KENZIE H&H HOMES - GARAGE LEFT

Buyer Marked MLP000740

KENZIE
H&H HOMES

Cover Sheet
 Kenzie Model - LH
 Up to 130 M.P.H.

FRONT ELEVATION
SCALE 1/4" = 1'-0"

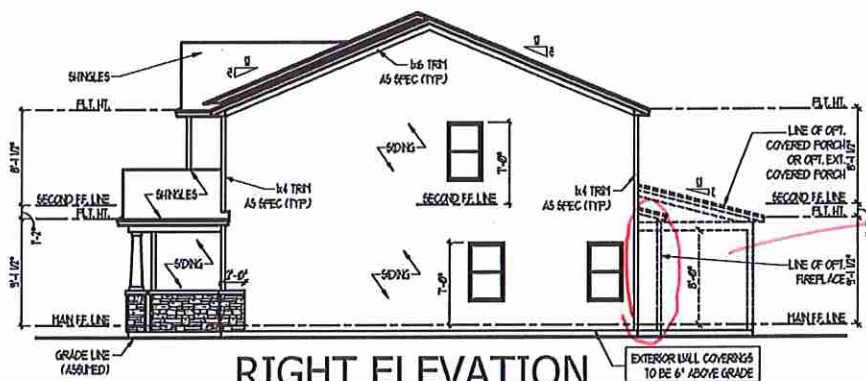
See Ranch style garage door
STONE
2 panel square front door
no grid

REAR ELEVATION
SCALE 1/8" = 1'-0"

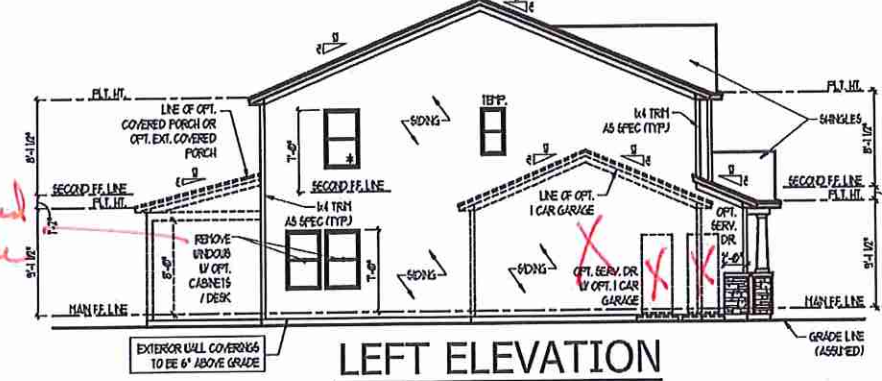
covered Deck

covered Deck

ELEVATION "B-2"

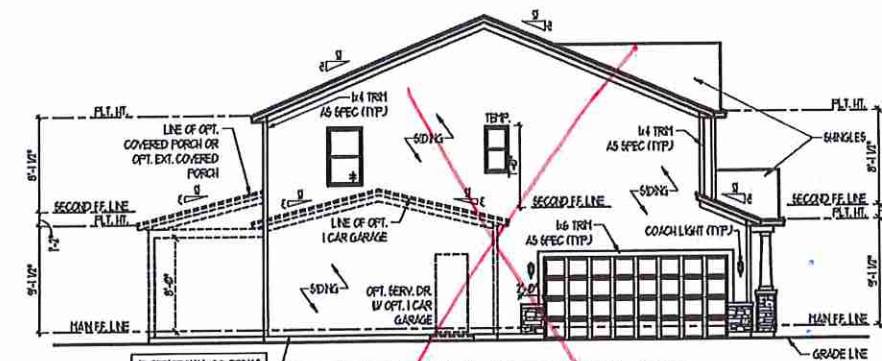
All windows are 4/1 grid pattern

FIRST FLOOR ELECTRICAL PLAN

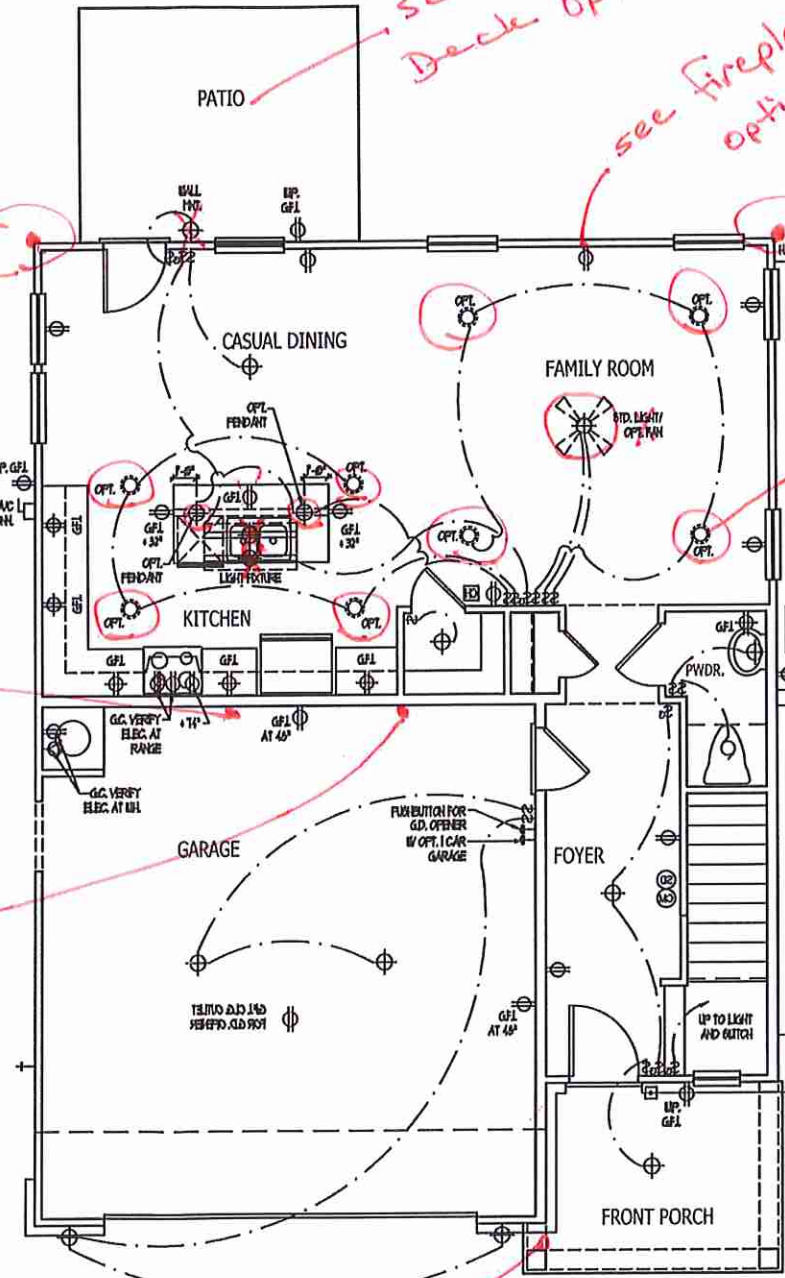
see covered Deck Option

see fireplace option

Flood light

Flood light

4 Recessed cans w/ Dimmer

Standard 110V R

dedicated 110V R

OPT. FIREPLACE

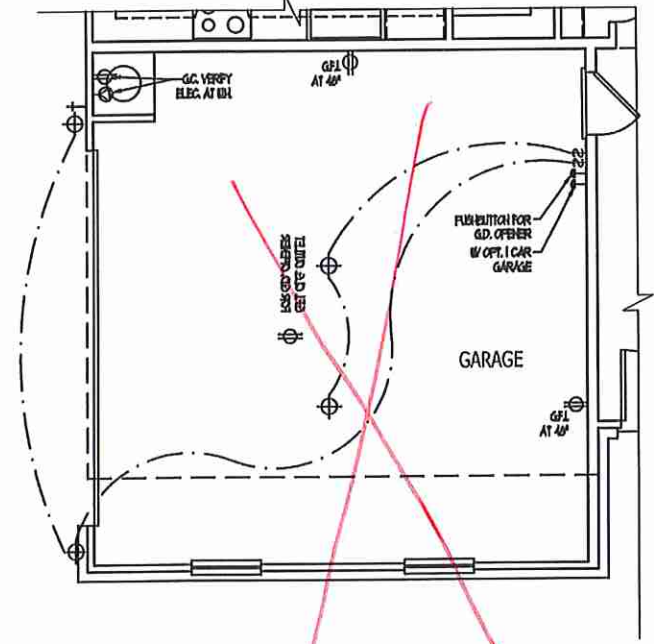
*110v @
for TV - see
CPI*

SECOND FLOOR ELECTRICAL PLAN

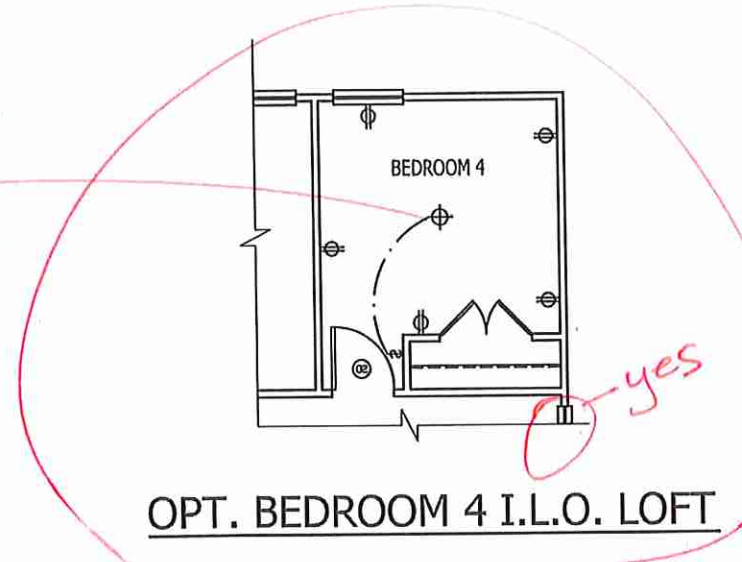
*light standard
provide for
fan/light*

CRAWL SPACE FOUNDATION PLAN
 ELEVATIONS 'A1' & 'A2'

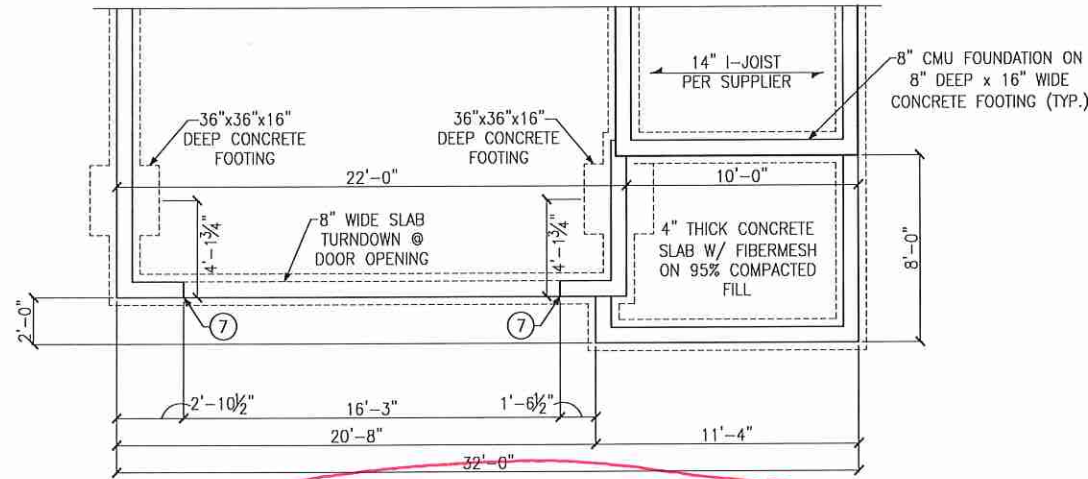
see elevation B2
